MIL-M-21393A
AMENDMENT 7
8 August 2002
SUPERSEDING
AMENDMENT 6
15 November 1968

MICROPHONE, DYNAMIC, M-92C/U

This amendment forms part of MIL-M-21393A, dated 1 July 1960, and is approved for use by all Departments and Agencies of the Department of Defense.

FIGURE 1A. Hand-held microphones M-92C/U.

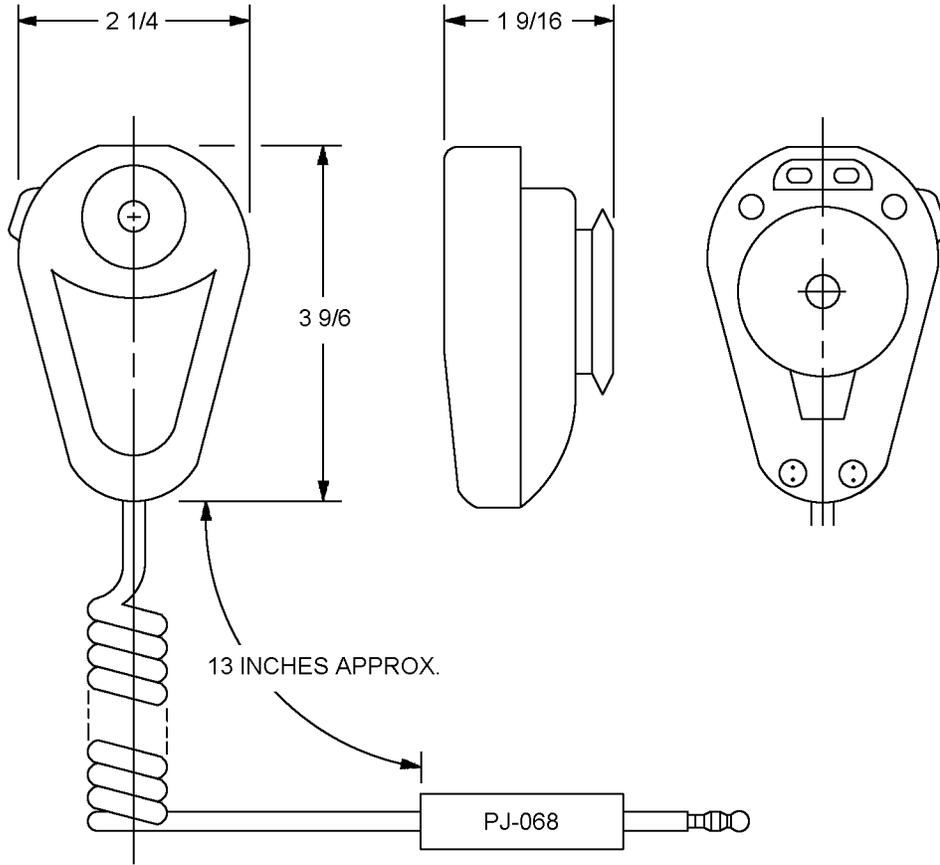
3.3.5, first sentence: Add: “or figure 1A”.

3.4.1.2: Add: “or figure 1A.”

Add as new figures:

Figures 1A, 12 and 13 (see pages 6, 7, and 8 below):

FIGURE 12. Frequency response.

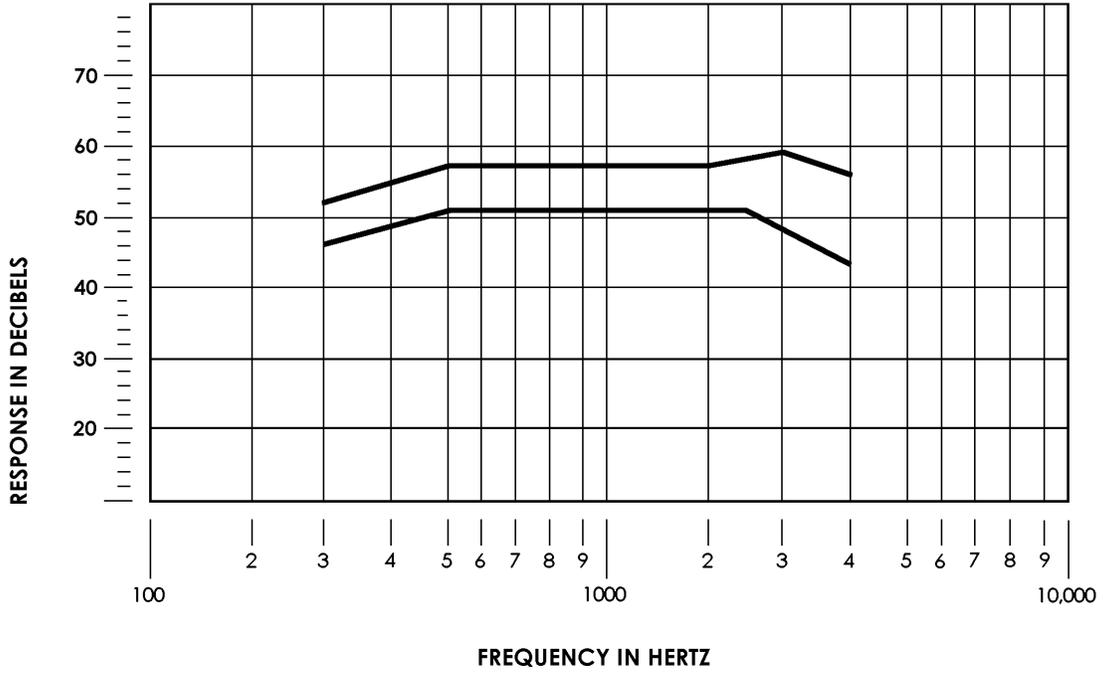
3.5.2: Delete “Table I” and substitute: “figure 12.”

Table I: Delete and substitute: figure 12.

FIGURE 13. Radiated radio frequency susceptibility test circuit.

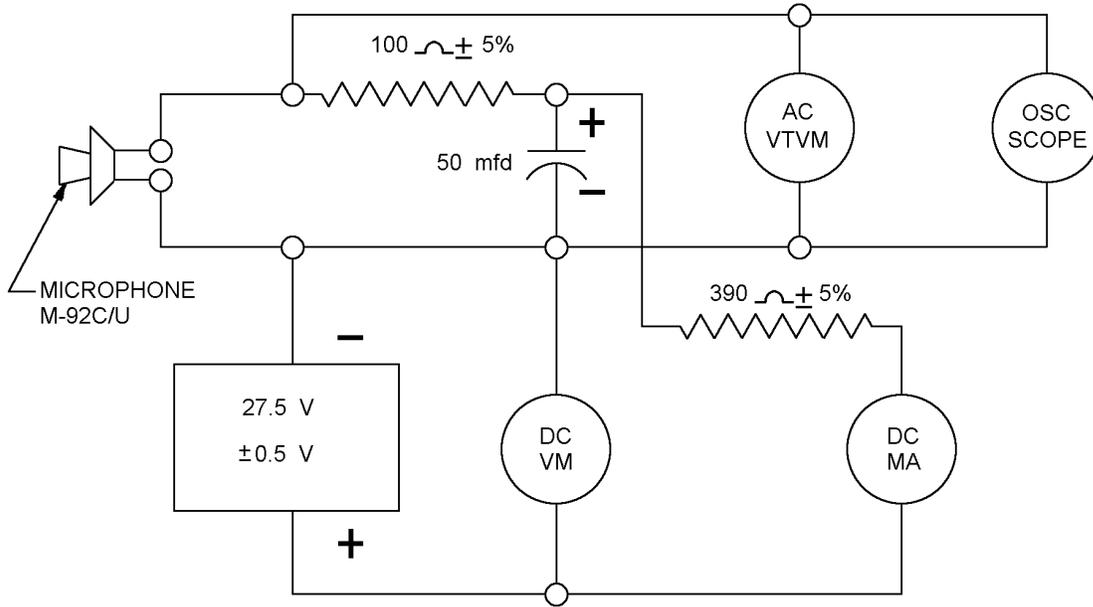
3.5.11.1 Radiated R. F. Susceptibility – The microphone, when connected as shown on figure 13, shall not evidence oscillation or other degradation of performance including extraneous signals or noise (i.e., output which does not correspond to a desired input) when subjected to any frequency and steady field intensity shown in table V. The microphone shall not evidence oscillation or other degradation when subjected to the required steady field intensity for a period of three minutes at nine frequencies including end and mid frequency of each frequency band of table V.
